BCA Assessment Report

ESR Huntingwood – Buildings 1-4
Augusta Street, Huntingwood
SSDA-36138263 – MOD 2 Submission

Reference: 250080

Figure 1- Building 1 Perimeter Vehicular Access

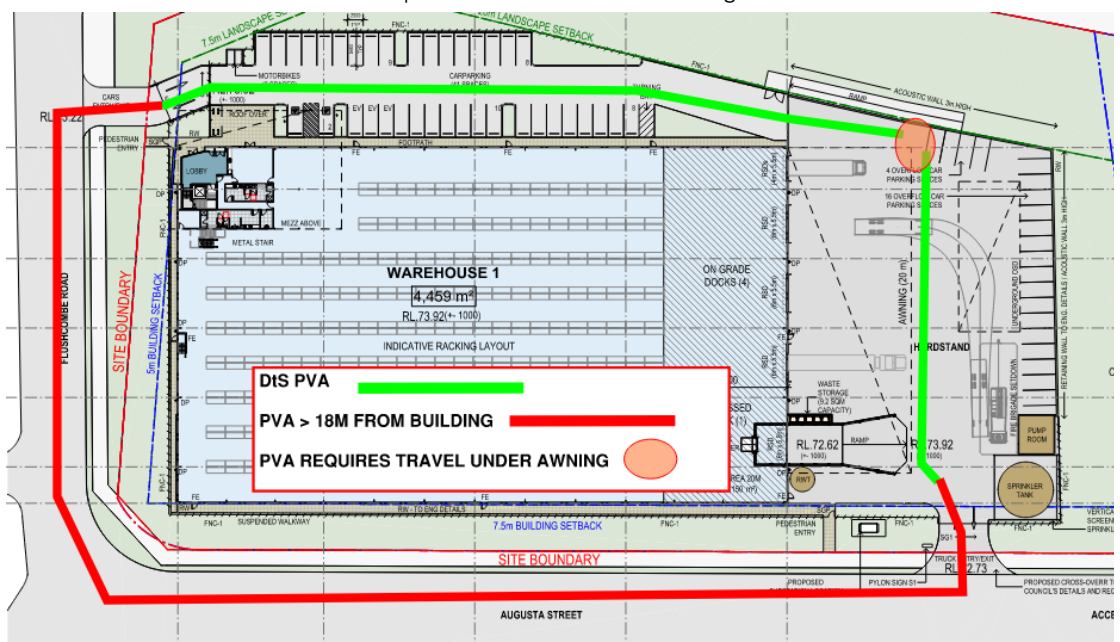
- Perimeter Vehicular Access is greater than 18m from the building around Augusta Street and Flushcombe Road.
- Perimeter Vehicular Access requires travel under the awning in the north-eastern corner.

Figure 2- Building 2 Perimeter Vehicular Access

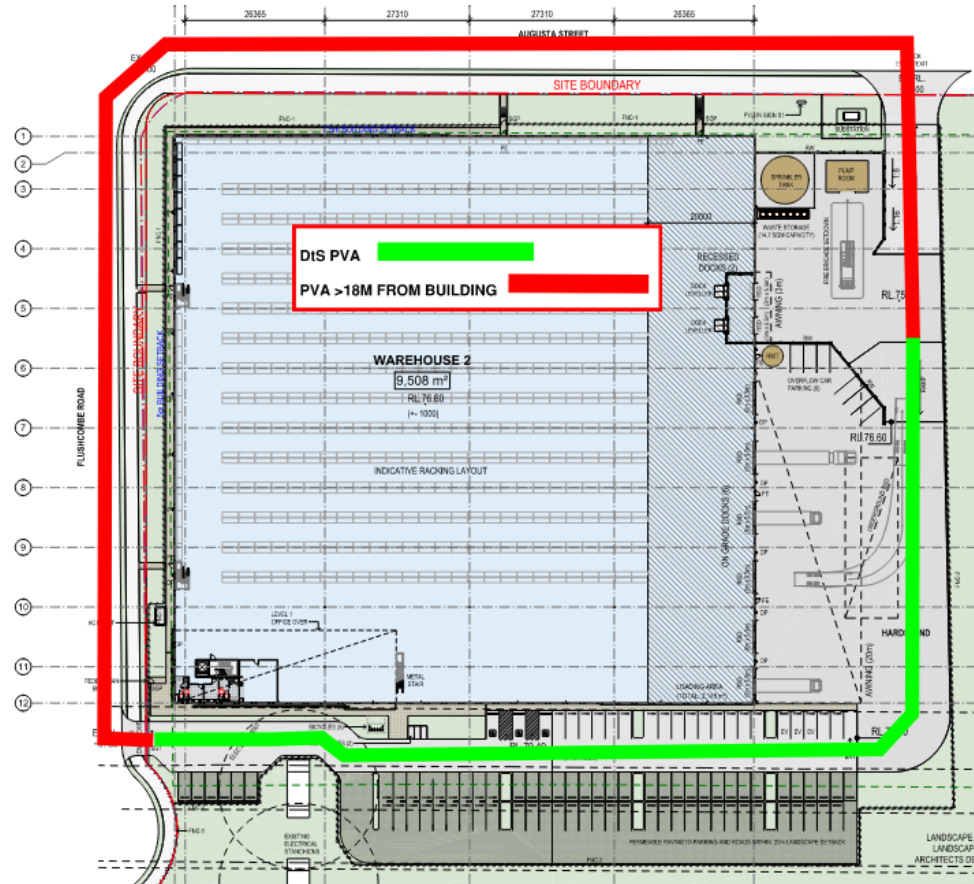
- Perimeter Vehicular Access is greater than 18m from the building around Augusta Street and Flushcombe Road.

Figure 3- Building 3 & 4 Perimeter Vehicular Access

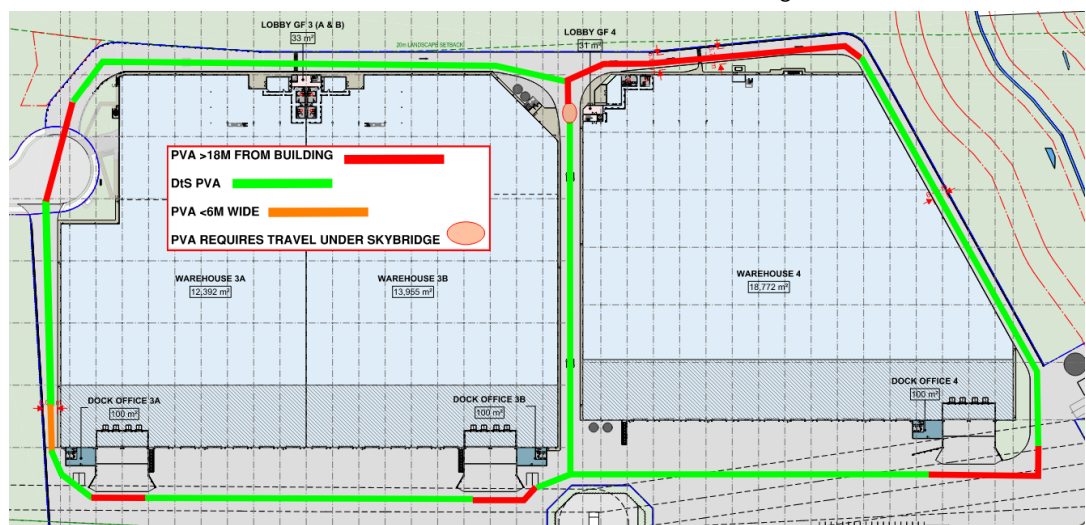
- The PVA requires travel under the skybridge in the northern end of the site between the two buildings
- PVA is greater than 18m from the building in parts of northern elevation of Building 4 and the southern elevation (along the recessed docks) in the southern elevation for both buildings
- PVA is greater than 18m along the cul-de-sac to Building 3
- PVA is less than 6m wide in the south-western corner of Building 3.

Figure 4- Figure 2- 4HR Fire Wall between WH4 + Skybridge from WH3

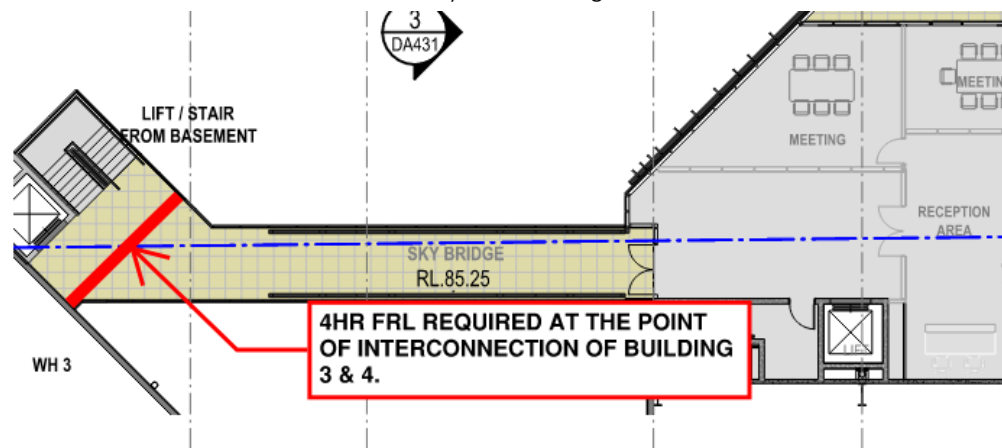
Comment: The fire wall as noted in the diagram separating the skybridge & Warehouse 4 from Warehouse 3 is required to achieve an FRL of 240/240/240. Any proposal to rationalize the FRL is to be addressed as a Performance Solution by the Fire Engineer.

Figure 5- Openings in External wall (B3&4) required to be protected in accordance with C4D5

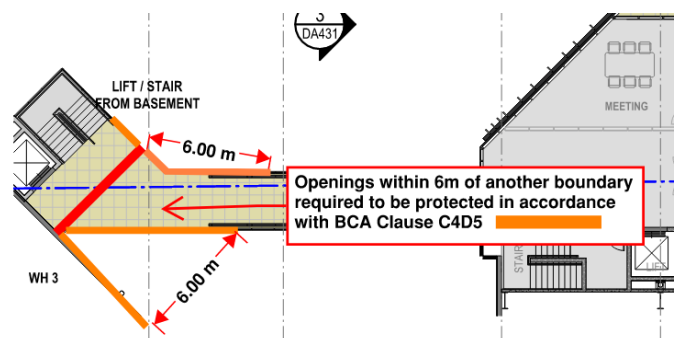
Comment: The openings in the skybridge and Building 3 that are within 6m from another building as identified in the markup below are required to be protected in accordance with BCA Clause C4D4.

Figure 6- Load-bearing Elements in WH3 within 18m required to achieve FRL.

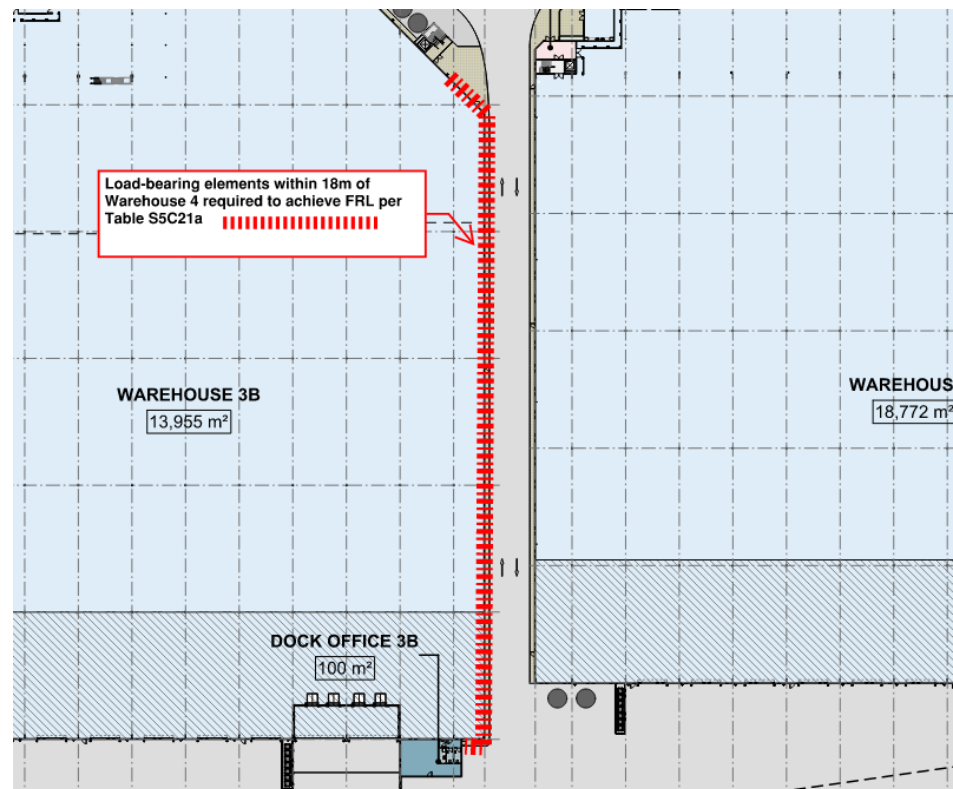
- + All internal load-bearing columns, & walls (excluding those providing direct support to the roof only) are to achieve the required FRL per Table S5C21g: 240/- FRL. Note: Applies to columns supporting the Level 1 Office and columns supporting the Ground Level Slab in the basement carpark.
- + The load-bearing elements in the eastern external wall of Building 3 is required to achieve an FRL per Table S5C21a where the wall is located within 18m of a building on the same allotment – see Figure 4 below.

Figure 7- External Walls of Building 3 required to Achieve FRL

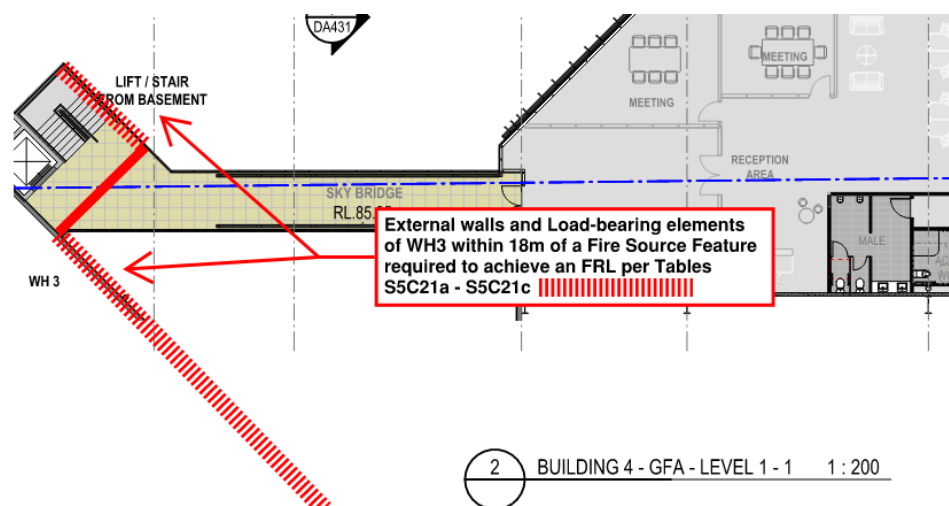
- + The portions of the Building 3 located within 18m of Building 4 and the Skybridge Structure are required to achieve an FRL per Table S5C21a

Figure 8- External Walls within 3m of Fire Source Feature of Building 4 required to achieve FRL

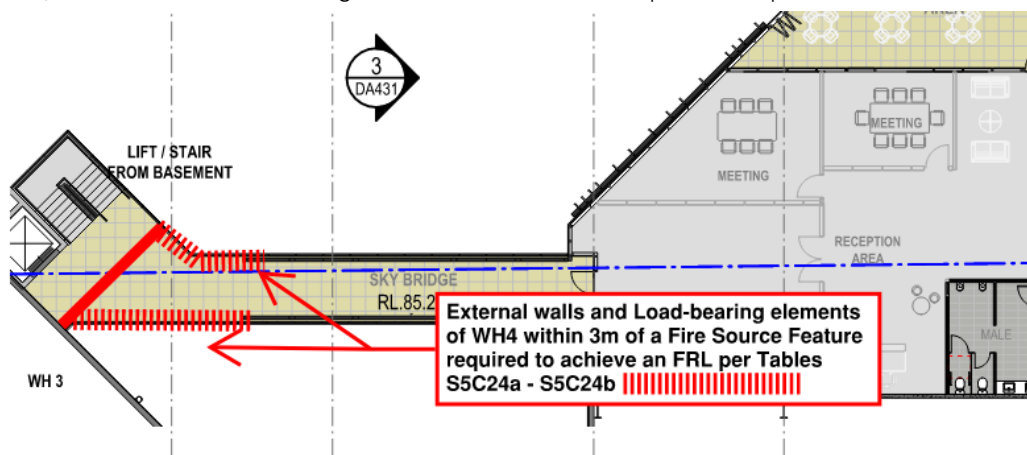
- + All external walls & loadbearing elements incorporated in or attached to an external wall are to achieve the required FRL per Table S5C24a.
- + All loadbearing external columns are to achieve the required FRL per Table S5C24b.
- + Any Fire Walls that are proposed to separate different classifications per C3D9 above are to achieve the required FRL per Table S5C24c.
- + All internal stair shaft walls and walls bounding SOUs, as well as any associated columns, walls, beams and trusses throughout are to achieve the required FRL per Table S5C21d.

Figure 9-External Wall within 6m of discharge path - 1HR FRL required

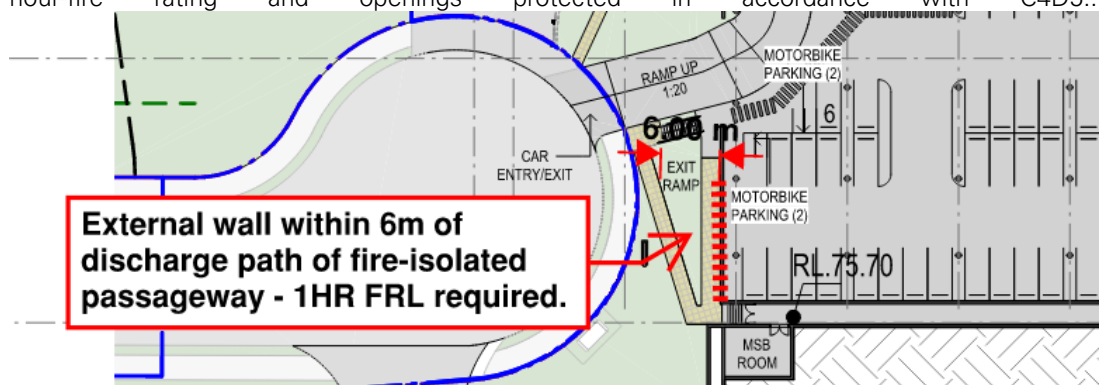
Comment: The discharge path of the fire-isolated stairway serving the basement carpark of Building 3 necessitates travel within 6m of the external wall. The wall is required to achieve a 1-hour-fire rating and openings protected in accordance with C4D5.
